Attachment A: MMD Technical Comments

No Agua Mine Revision 23-1

Permit No. TA005RE

Name of Operator: Imerys Perlite USA Inc. **Permit Update:** 5-year Closeout Plan Revision 23-1

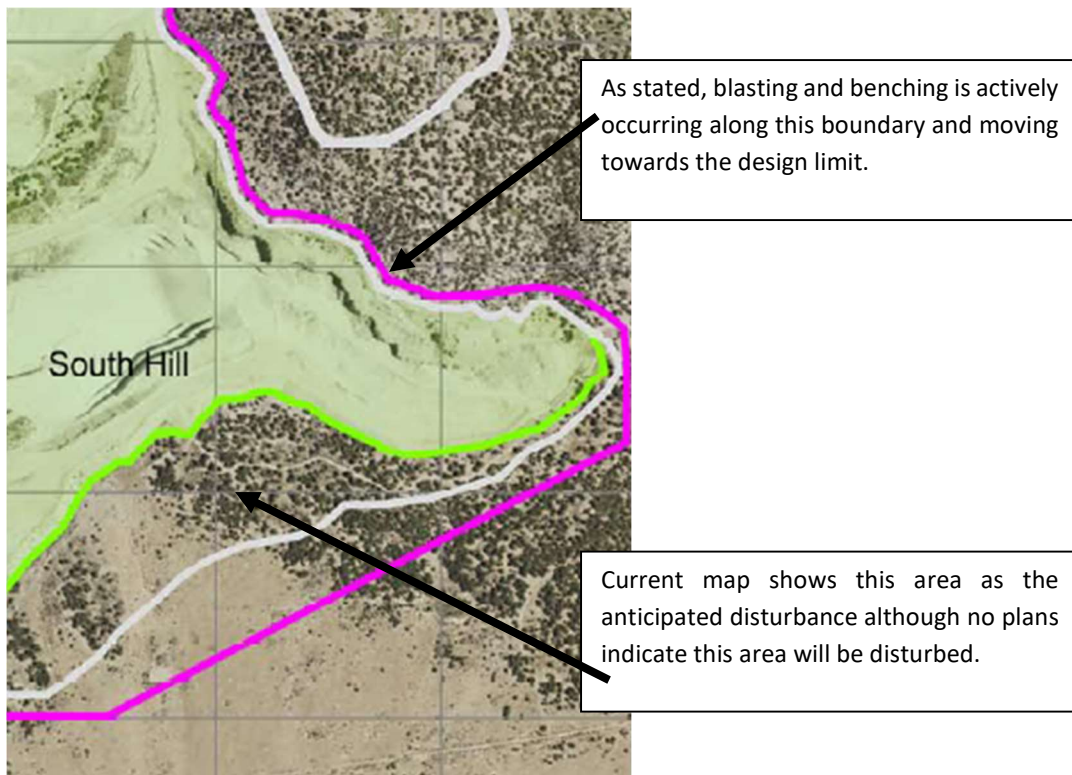
24. Figure 1: MMD is requesting updated maps for on-going and future reference. MMD is requesting the below characteristics be included.

- a. Confirm 5-year disturbance/design limit for South Pit (see annotated map below),
- b. Fines dump locations (including prospective third dump location, if needed),
- c. Overburden dump,
- d. Cover material storage,
- e. Label the new "508" and existing units "507",
- f. Well location,
- g. New proposed test plot locations,
- h. Historic test plot locations (3) and,
- i. Catch Basins (4)

Please see Closeout Plan Figures 5 through 13.

In the eastern portion of South Hill, the 5 Year Disturbance boundary has been pushed out so that it is at the limit of the 2016 Design Limit. This is to accommodate mining in this area.

Area to the south of South Hill will be disturbed to source borrow material for the Test Plot Program. Core drilling and mine development in this area is also possible.

Reference Area Locations

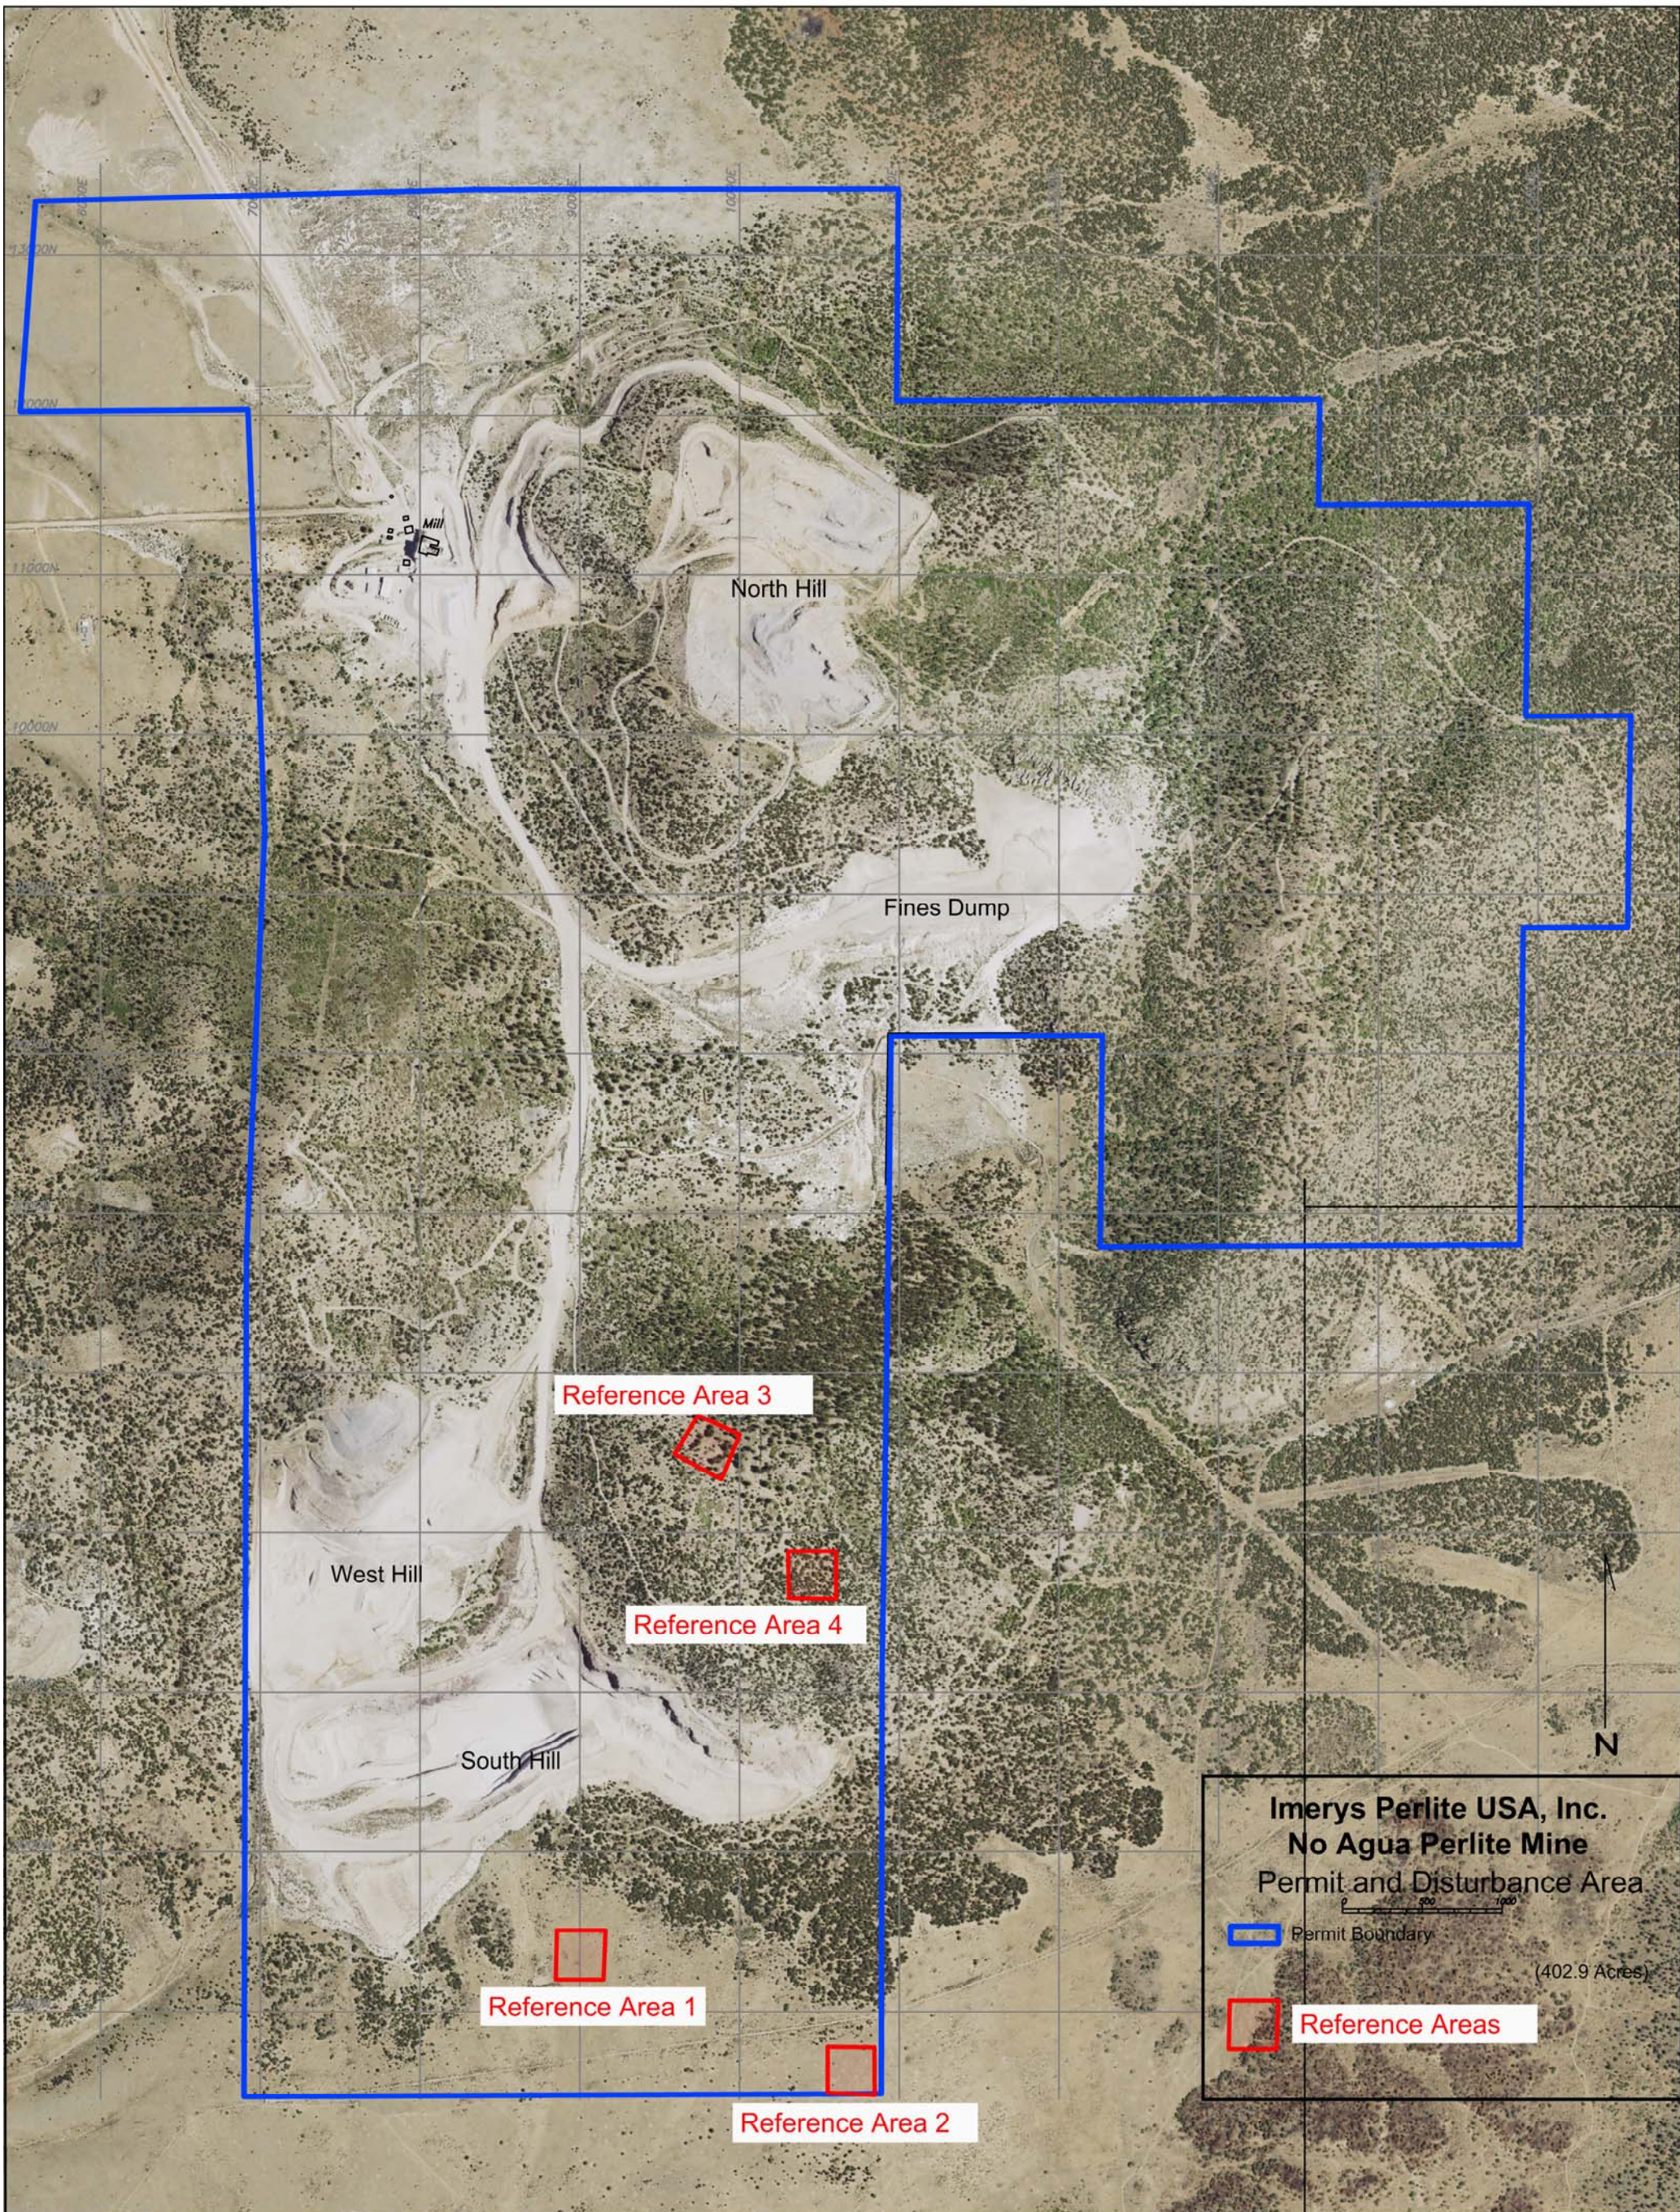
17. Section 6.2: Cover states that "The 508 governed areas are indicated in Figure 4", but those areas are not delineated in Figure 4. Please include a delineation of the existing units (19.10.5.507 NMAC) versus the new units (19.10.5.508 NMAC) in an updated map (*See also comment 25 on Figure 1 below*).

See Closeout Plan Figure 7.
